ADDENDUM NO. 1

Project: 2018 Caesar Ave Street Improvements

Owner: City of Kingsville

Issue Date: 2/21/2019

2
5
SINGLE COURSE SEAL TOP LAYER
WITH
FULL DEPTH CONSTRUCTION DETAIL
BASE BID
STA. 4+25 TO STA. 32+00

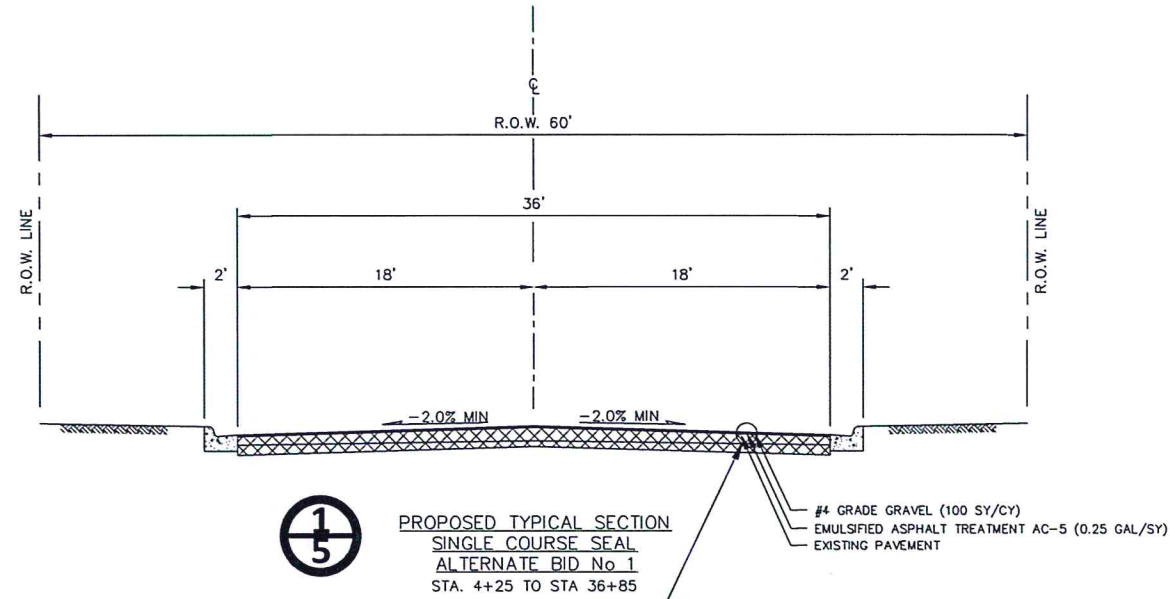
1. Removal and disposal costs of existing base material shall be included in BID items B-2 and B-3. Saw cutting, removal and disposal costs of existing asphalt shall be included in BID items B-6 and B-7.
2. Single course seal aggregate application rate shall be 100 SY/CY for the No. 4 grade gavel.
3. Revised Bid Proposal is posted on <http://www.cityofkingsville.com/departments/purchasing/rfpbid-openings-fy-2019/> last updated February 1, 2019.
4. Revised Pavement Details and notes on Construction Plan Sheets 4, 5, 6, and 11.
